**Section:** 303-01A (21)

**Model:** 2001 Mondeo 1.8L/2.0L Duratec-HE with engines built in Chihuahua (Mexico) up to 06.12.2000 inclusive

**Subject:** Engine cranks but will not start, severe loss of power, increased fuel consumption, engine knock, rough running or misfiring

**Production Action**

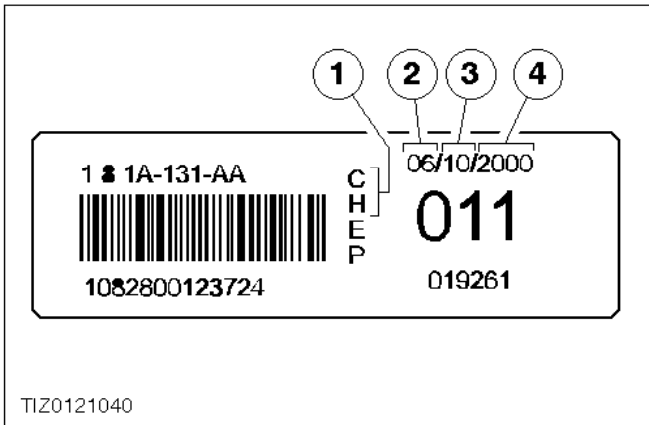
A revised vibration damper bolt has been installed in production since 07.12.2000 (build code YT) in conjunction with an additional washer and a revised tightening torque.

**Check Thickness of Vibration Damper Bolt Washer**

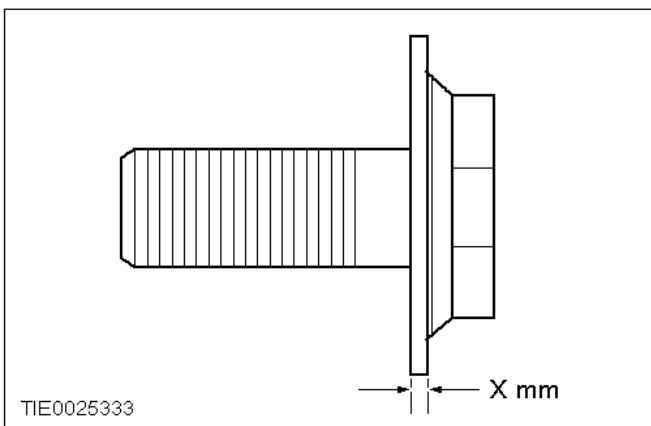
- 25. Measure the thickness of the vibration damper bolt washer.
  - If the thickness is less than 5.5 mm, discard the friction washer. Go to next step.

- If the thickness is greater than 5.5 mm then a new friction washer has already been installed. Reinstall the existing washer and go to step 27.

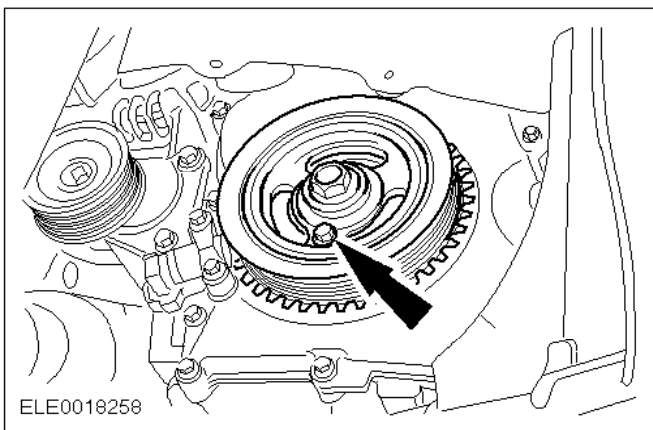
Installation position of the friction washer between the sprocket and the vibration damper.

- ⑥ 26. Install the friction washer (see Parts Required).

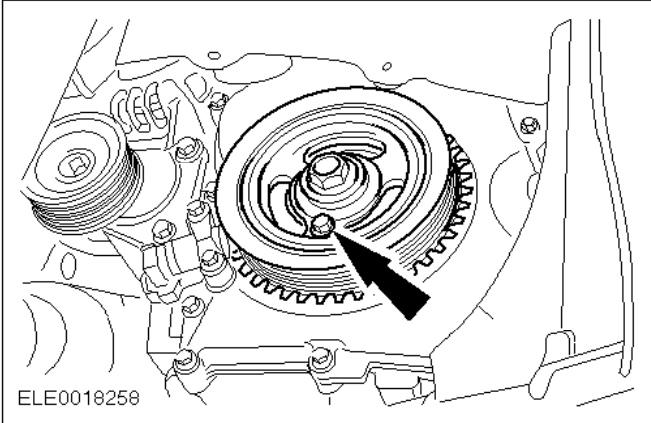
- ⌚ 28. Install a new crankshaft vibration damper bolt (see Parts Required).
  - Using the special tool, hold the crankshaft vibration damper.
  - Tighten the bolt in two stages.
  - Stage 1: 100 Nm
  - Stage 2: 90 degrees
